AMERICAN CAR AND FOUNDRY CO.

31-20890

CORRUGATED DROP END

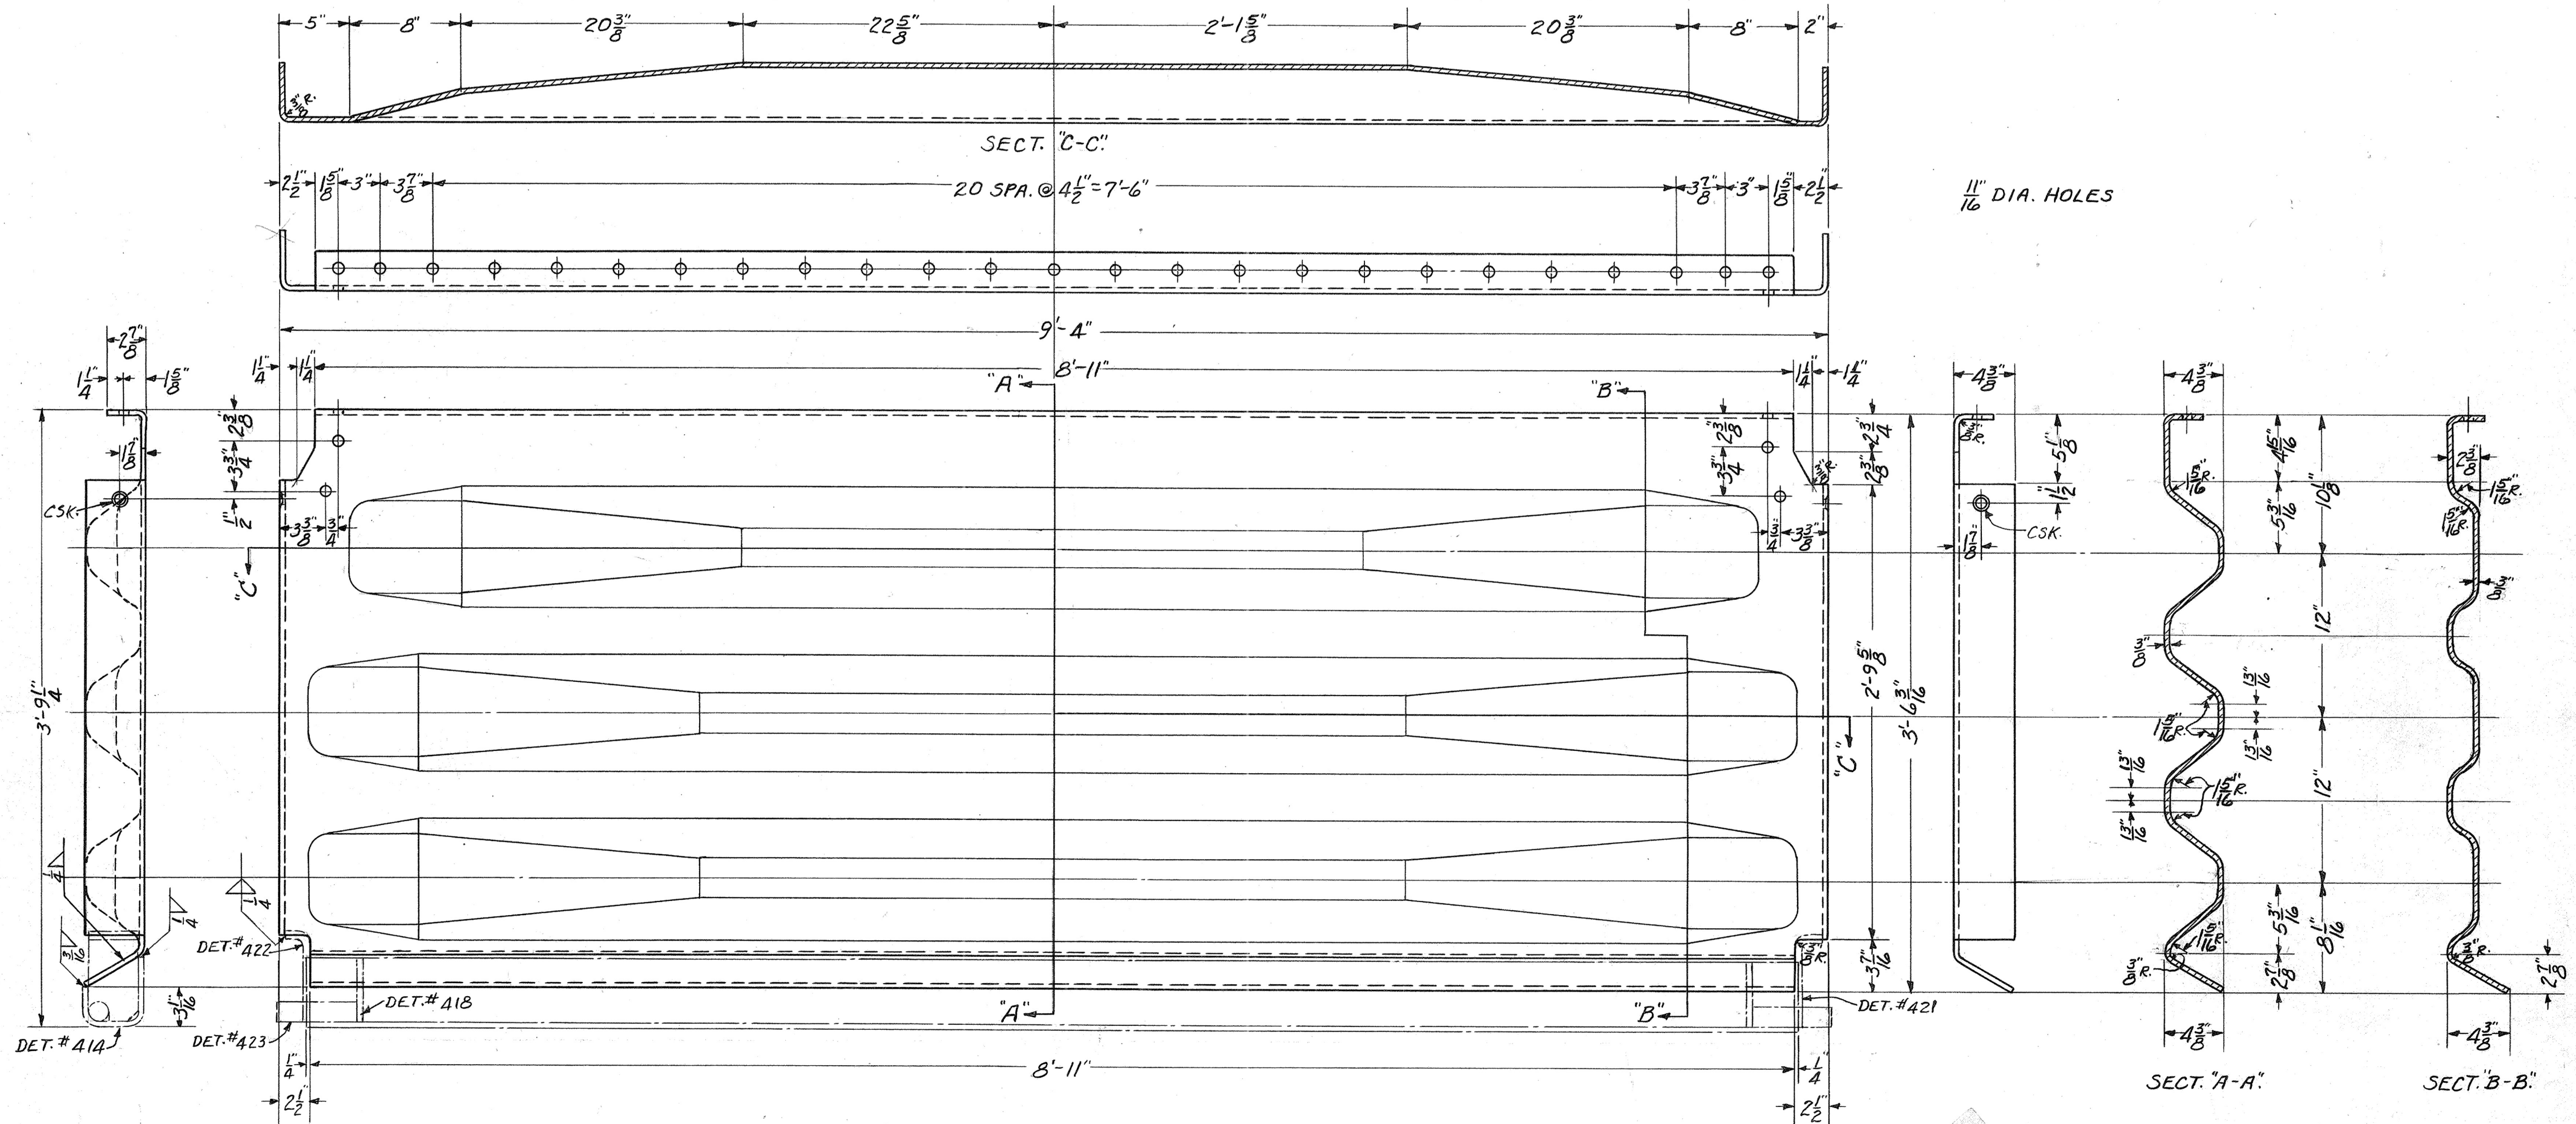
RED 5-11-48 REV. "B": 1 1/4" RADII CHANGED TO 1 5/8" AND 15" R. REMOVED.
 RED 4-2-48 REV. "A": COPE AT BOTTOM CHANGED; WELDING ADDED FOR DET. #414. HOLE IN FLANGE CSK.
